Michael Riordan

Comment on the Draft NEPA Environmental Impact Statement for the Millennium Bulk Terminals — Longview

by Michael Riordan, Ph.D.

Fig. 2. Coal dust accumulations on the Salish Sea floor adjacent to the Westshore Terminals during a 22-year period from 1977 to 1999 (Johnson and Bustin, ref. 17).

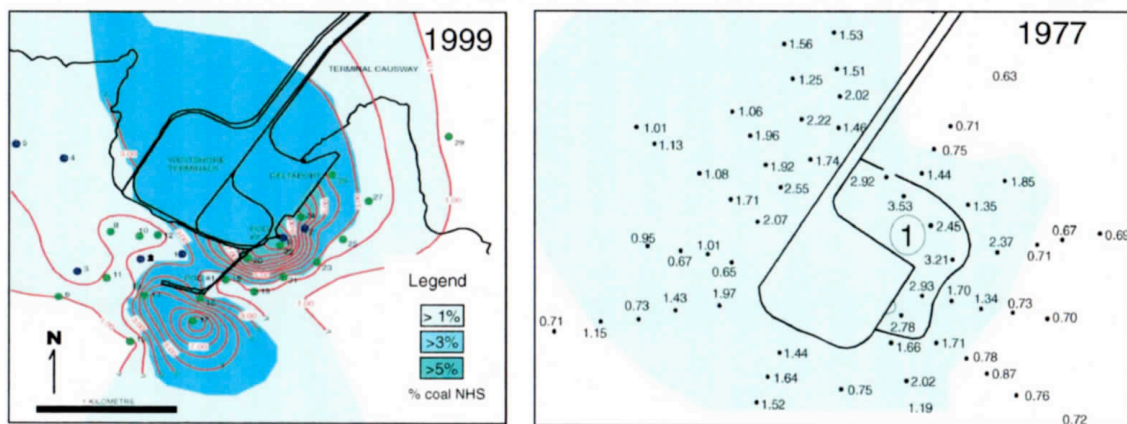
All told, including coal dust losses from ship loading (plus that due to operator error), from uncovered conveyors leading to the piers, and from the remaining terminal operations, one can readily estimate that between 10 and 15 tons of coal annually will fall into the Columbia River near the MBTL piers. An idea of the cumulative impacts of these losses can be obtained from an analysis of the sea floor at Westshore Terminals (Fig. 2).¹⁷

In this instance, the quantity of coal loaded annually was substantially less than half the amount that would be loaded at the MBTL piers, about 22 million tons/year or less, and the loading process was similar, with uncovered conveyors extending over the water and loading chutes that extended well down into the ship holds. Note that coal accumulations of 5 percent or greater were measured just southeast, or downwind in the summer, from the two loading piers at Westshore Terminals; closer to the piers, coal particles exceeded 10 percent of the material sampled from the sea floor. Examination of the coal in these areas revealed large-size particles greater than 100 micrometers in diameter, which most likely occurred from spillage due to operator error, as they are too large to have come from wind-driven fugitive-dust processes.¹⁸ This observation demonstrates that estimates limited to wind-driven coal dust, as done in the SEPA and NEPA environmental impact statements for MBTL, will *dramatically underestimate* the amount of coal particles that reach the floor of the Columbia River. Coal losses in loading due to operator error are extremely important and cannot be ignored — as they were in those studies.

²⁴ A good comparison with the Westshore example can be found in Fig. 2, where one will note a large blue dust plume extending NW of the terminal, obviously due to the strong SE winds that occur every winter.
